April 4, 2016

Representative David Deen
House of Representatives
State of Vermont
115 State Street
Montpelier, VT 05633-5301

The purpose of 6216-INDS's Condition 14, the subject of my testimony, was to ascertain if the Alternative Stormwater Treatment Practice components up at the elevation of the project are functioning to meet the specific performance standards outlined in the VT Stormwater Management Manual (VSMM). These include 1) Water Quality, 2) Channel Protection, 3) Groundwater Recharge, Overbank Flood Protection (10-year recurrence flood), and Extreme Flood Protection (100-year recurrence flood). This is accomplished, according to GMP's consultant, via photo-documentation, video and water sampling during storm events. The purpose of this required study would be to understand if the modeling was accurate and if the system will function in accordance with the regulations. The water quality monitoring, part of the 401 Water Quality Certificate and distinct from Condition 14 of 6216-INDS, is performed thousands of feet to miles downstream, and solely focuses on biological integrity at that location.

Wet Pond K at turbine T-14. Note, there is no permanent water pool in the basin. This is typical of 11 of the 13 ridgeline wet ponds (Sheet C-114 of the Operational Stormwater Plans, VHB, last revised June 2011).

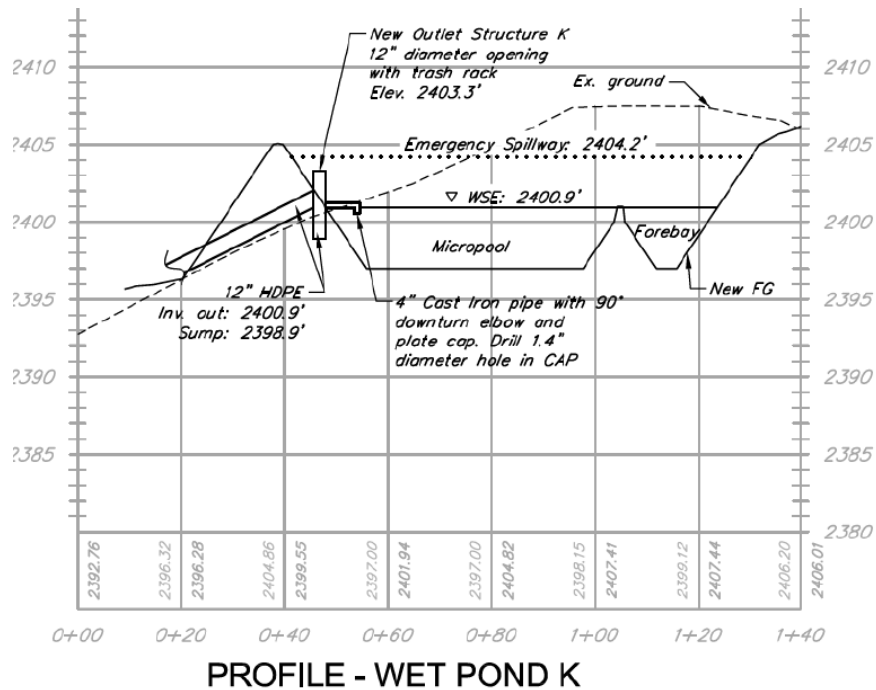
These include 13 wet ponds located along the crane path on the ridge. A wet pond’s effectiveness in removing pollutants is predominantly reliant upon the permanent pool (emphasis) that is provided to settle out suspended solids, contaminants, and nutrients. Of these 13 wet ponds, 11 of them are nearly or completely dry (empty) with no permanent pool. It is my opinion, and having been in the vicinity of several of the wet ponds back in 2013, that runoff entering the wet pond simply escapes the basins through the fractures in the rock and discharges to the mountain slopes immediately downhill. This means that the required portion of the water quality storm volume is not stored and treated in accordance with requirements of the VSMM. An example of the condition of a wet pond is in the figure below, with the engineering plans overlain on the aerial photograph. This is typical of the other empty “wet” ponds.

Profile of Wet Pond K at turbine T-14. The Forebay and Micropool are required to be permanently inundated (Sheet C-121 of the Operational Stormwater Plans, VHB, last revised June 2011).
